Attachment No. 8

TECHNICAL COMMITTEE RECOMMENDATION

TECHNICAL COMMITTEE: Bicycle Technical Committee

TOPIC: Proposed Shared Lane Marking
Part 9 of the MUTCD

Diagram from San Francisco Shared Lane Marking study

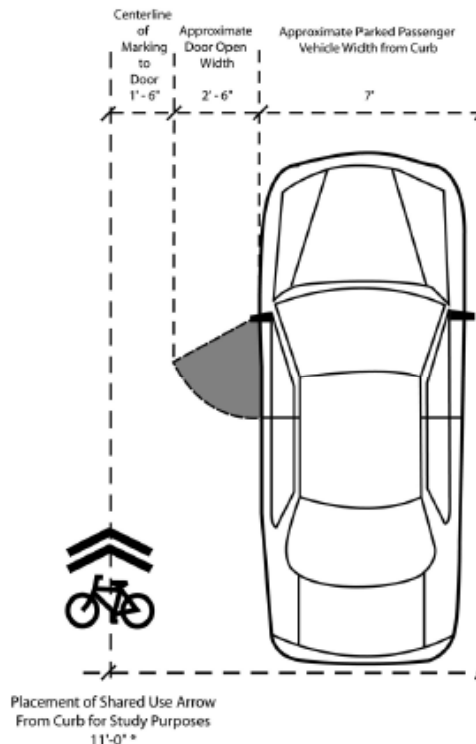
The results showed significant improvements to bicyclists' and motorists' positioning in the roadway, and identified the bike-with-chevron marking as most effective. These results have since provided guidance to the California Department of Transportation (Caltrans) to adopt the Shared Lane Marking in the California Supplement to the MUTCD.

Results from the San Francisco study indicate that the shared lane marking:

- Improves positioning of the bicyclist and motorist
 - Increases the distance between bicyclists and parked cars (by 8 inches in the SF study)
 - Increases the distance between overtaking motorists and bicyclists (by 2 feet in the SF study)
- Improves bicyclist behavior
 - Reduces wrong-way bicycling, a major cause of collisions (by 80% in the SF study)
- Reminds motorists of likely bicyclist presence
 - When surveyed, motorists claimed they did not notice the marking; however, the data indicates that their position on the roadway was adjusted to better accommodate bicyclists.
